2. Preliminary Review of the River View Villas Project 16-FDP-01 and TTM 31058

CITY OF BUELLTON
Planning Commission Agenda Staff Report

To: The Honorable Chair and Commission Members
From: Andrea Olson, Assistant Planner
Date: May 5, 2016
Subject: Preliminary Review of the River View Villas Project
16-FDP-01 and TTM 31058

Initial Staff Review

Site
1/16" = 1'-0"

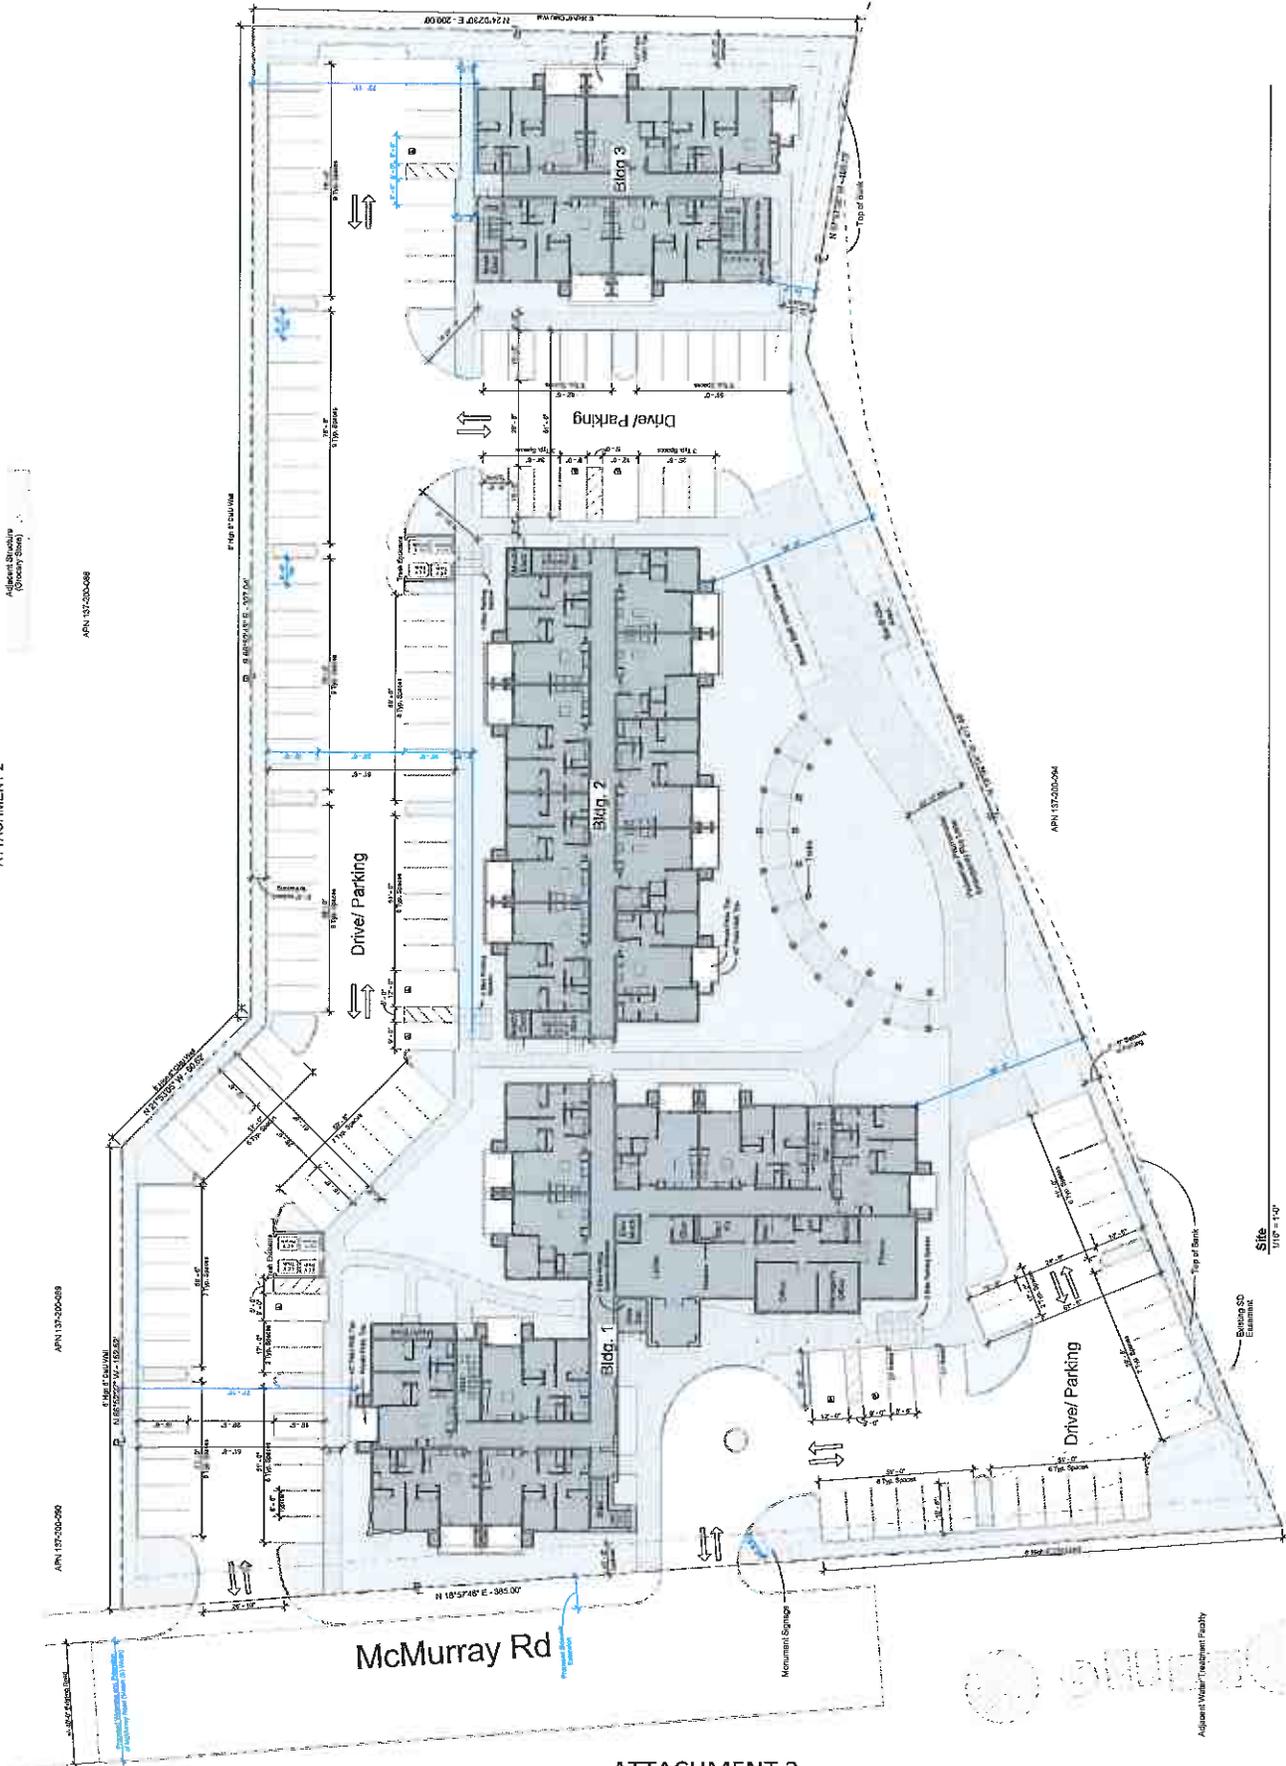
- Staff has a safety concern with a high density residential project located next to our water treatment facility on McMurray Road. The City and our consultant will review the report submitted by the applicant as part of the Initial Study. The City's primary concern is the catastrophic release of chlorine gas, which is not addressed in the report. Alarms and notifications are no help if a tank bursts during an earthquake or other type of disaster. None of the recommendations from the applicant's report would mitigate this impact. The applicant's recommendations include options that are long-term plans for the City. Any expediting of these plans, including the alternatives feasibility analysis and preliminary design, would be at the expense of the applicant, including any improvements/modifications to the water treatment facility.

- In addition, due to the location of the site to the water treatment facility, staff recommends that a secondary access be made on the east end of the site.

- Staff recommends, consistent with other larger multi-family projects, that an outdoor children's play area be added to the plans.
- The 20 foot wide bike/trail easement along the river shall be shown with a connection to the sidewalk on McMurray Road. The McMurray sidewalk needs to be extended southerly to make this connection.

- In order to provide space for trees along the north property line, the planter shall be increased to 8 feet in width. Per our landscape consultant, oak trees on the north perimeter are too constrained in the area between the perimeter wall and the parking lot. A more appropriate species is recommended, such as Brisbane Box that will screen and fit the appropriate space.

- Street trees shall be added to the plans along McMurray Rd.
- The plans indicate a monument sign will be located at the southern entrance of the project, however no details of the design of the sign are provided. The plans will need to be revised to show dimensions and materials for all proposed signage.

Bldg. 1 & 2 - Exterior Elevations

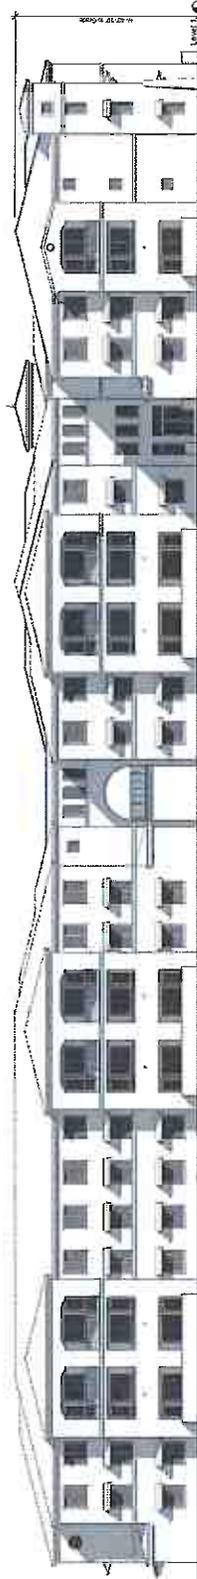
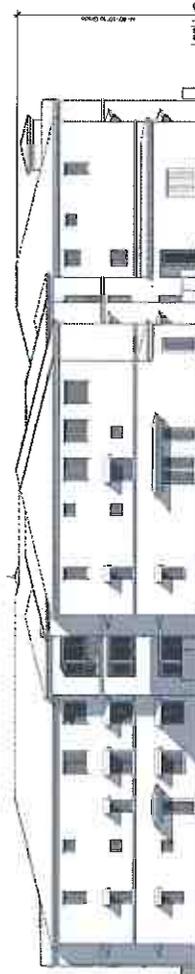
- Height Limit Modification: The applicant has submitted a request to modify the height requirement to allow a maximum height of 41 feet. The highest point of the proposed building is 40.83 feet. Per code section 19.02.220, the maximum height allowed in the CR zone is 35 feet. Modifications to the height requirement are allowed per code section 19.08.120 (G), when such modifications are justified. The increased height would allow for a pitched roof, which the applicant believes would be more attractive than a flat roof. Additionally, the perceived height of the building would be lower with a pitched roof (See Attachment 4). A Development Plan Modification will be required for the height.

- Full architectural details and material call-outs shall be provided on the elevations. Color elevations shall be submitted.
- The level of environmental review will be determined after all of the special studies are completed and we have prepared the initial study.

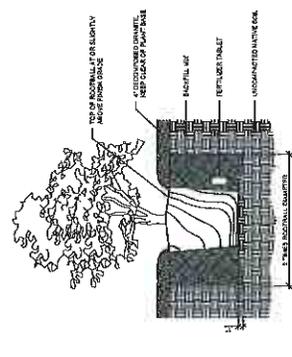
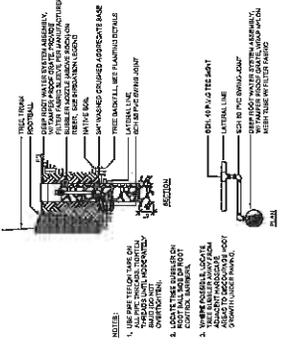
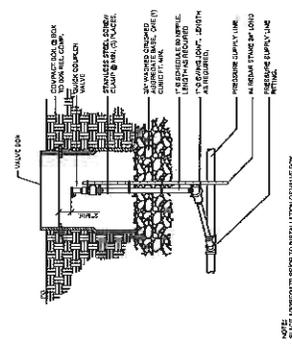
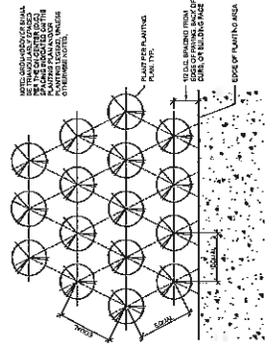
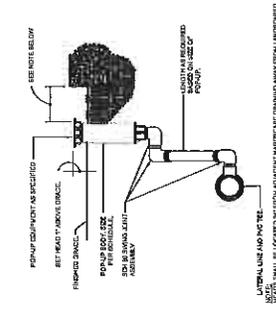
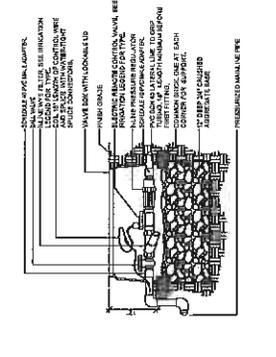
Irrigation details shown are appropriate. Final design will need to show all state mandated elements such as rain shutoff, flow sensor etc.

Height Analysis - Flat Roof

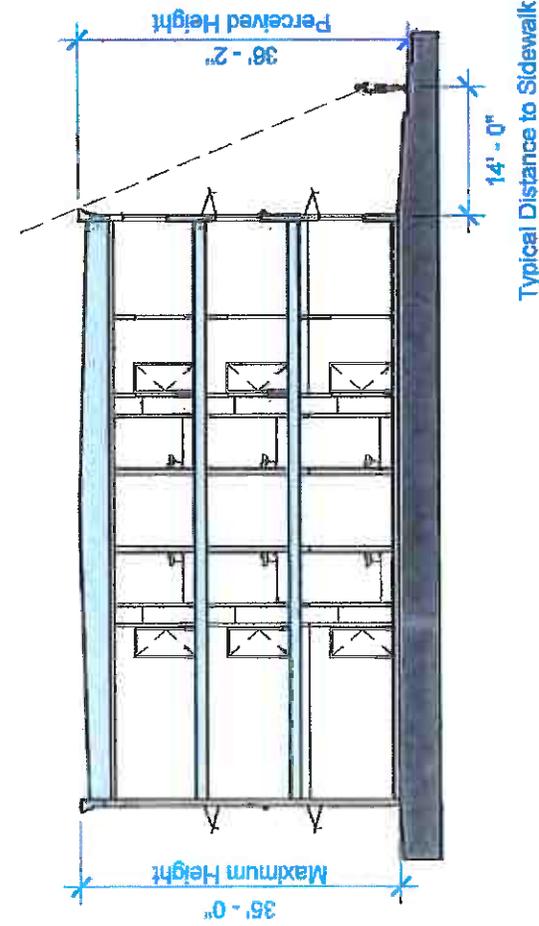
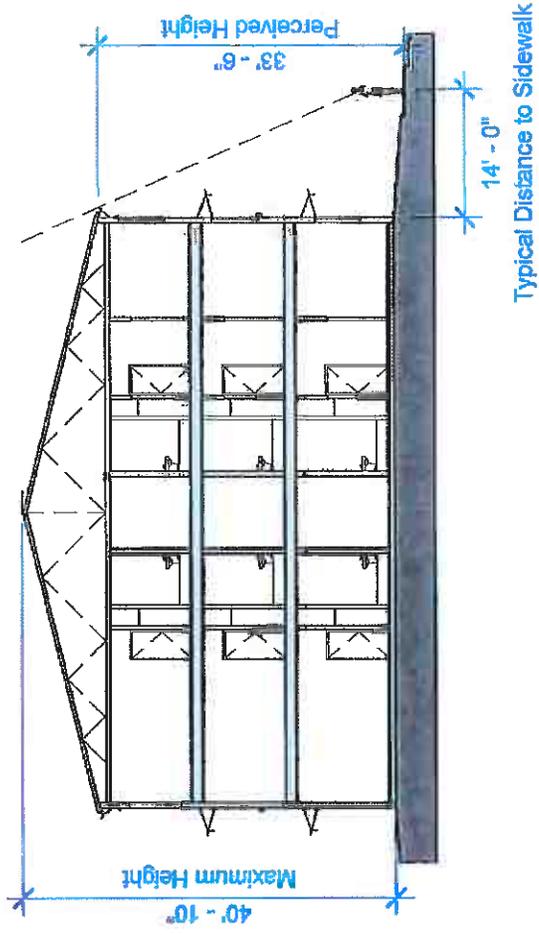
Though a flat roof design could meet the 35' height limit, the required parapets would actually increase the perceived height of the building to the typical observer.
